COMMISSION ACTION FORM

**REQUEST: MAJOR SITE DEVELOPMENT PLAN (LANDSCAPE PLAN) FOR
“OUTLOT A” (3201 UNIVERSITY BOULEVARD) AND “OUTLOT D”
(2036 COTTONWOOD ROAD), VILLAGE PARK SUBDIVISION**

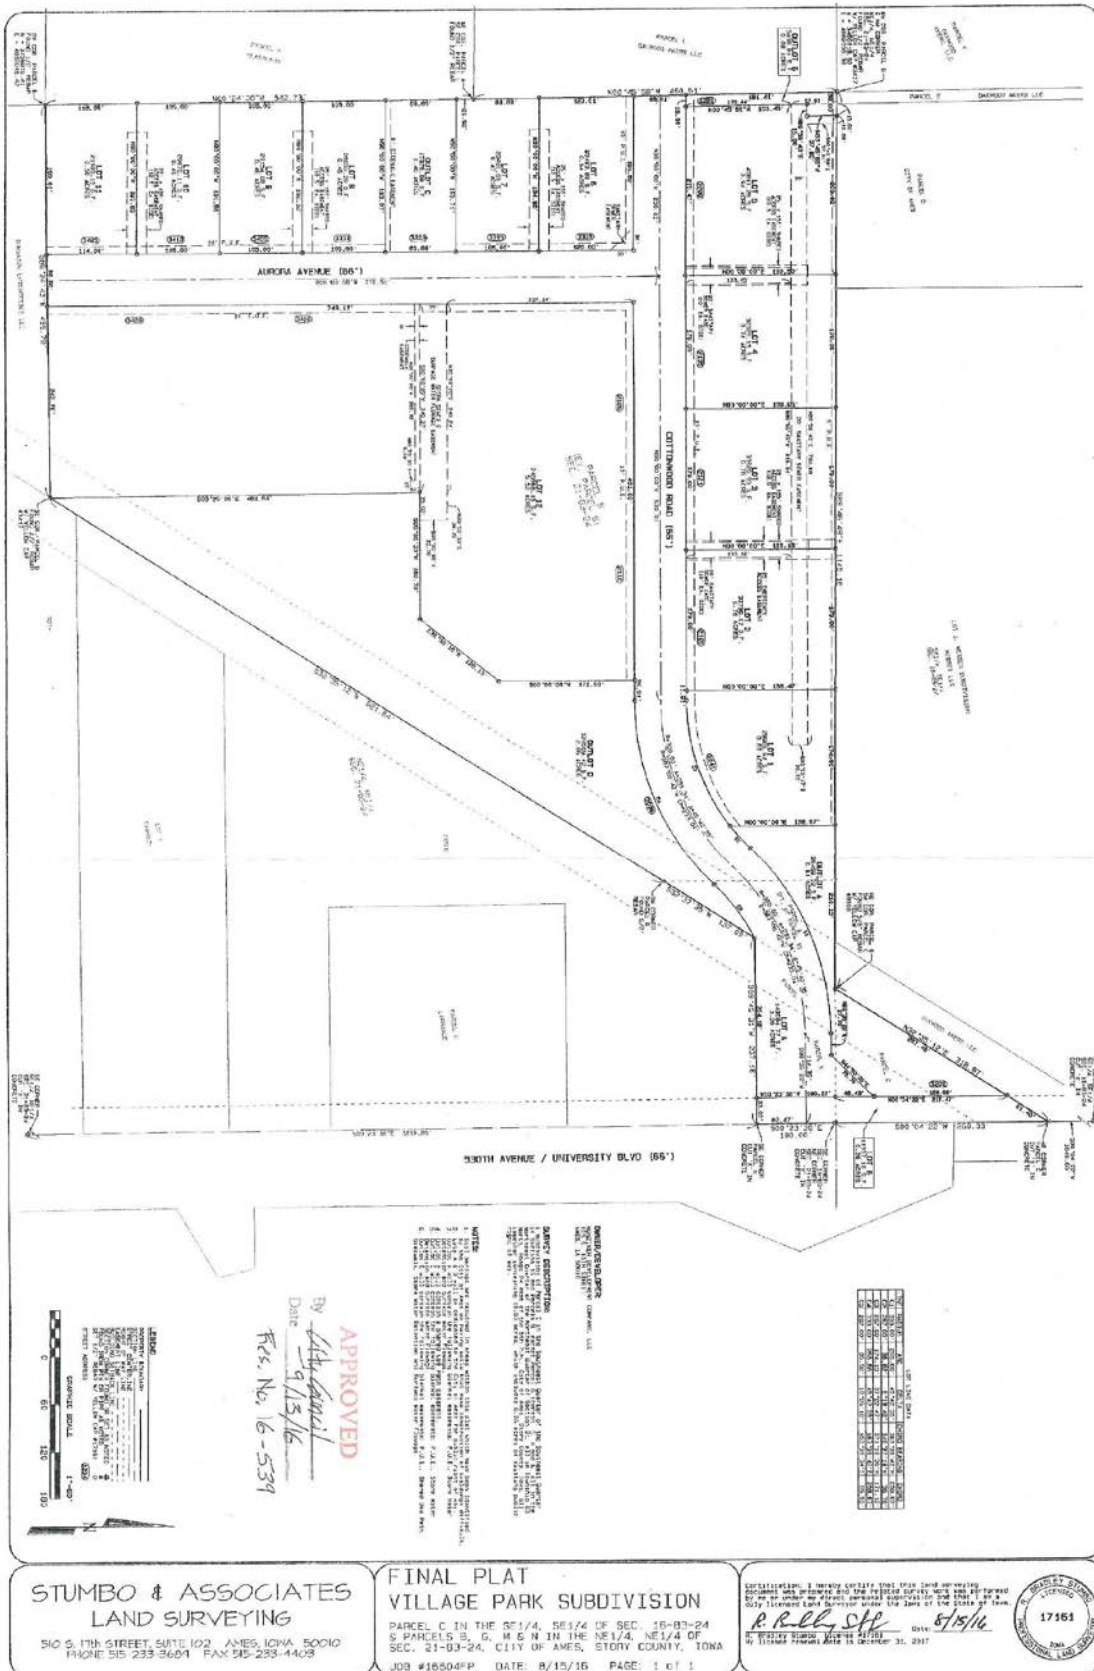
Outlot D includes an area for the shared use path (10 feet wide) next to the west boundary of Outlot D, and a small area for two trees, three shrubs and a bench. This path connects to the shared use path that will be constructed within the right-of-way on the north side of Cottonwood Drive. The proposed location of the shared use path to the south is approximately two feet from the west boundary of the outlot. The path is generally within 10 to 3 feet from the edge of the slope of the stormwater pond. The

interface to the west of path will be with a parking lot of the RH apartment development. The RH apartments will likely have a 5-foot planter with an L3 screen of a fence or high shrubs. Staff has concerns about the design of the path up against the RH property line due to the interface with the buffering. The path was originally intended to be on the east side of the outlot but during the Master Plan and subdivision review was asked to be placed on the west side by the residents living east of the site. Staff believes having a greater separation from the RH would better meet the design principles for open well landscaped areas within suburban zoning. The developer is concerned that adjusting the path location further from the property line would affect their stormwater detention design and impact the overall project design.

Outlot A abuts the shared use path in the right-of-way for Cottonwood Road. The Developer is proposing two groupings of one tree and two shrubs along the northwest perimeter of Outlot A, and a single shrub between the two groupings. Landscaping of the two outlots with trees, shrubs and amenities for the residents of Village Park Subdivision is minimal, beyond the shared use path that is routed through Outlot D. Staff believes that adding two large street trees at the southwest intersection with University Boulevard would tie the site together better than the two open areas that are now proposed.
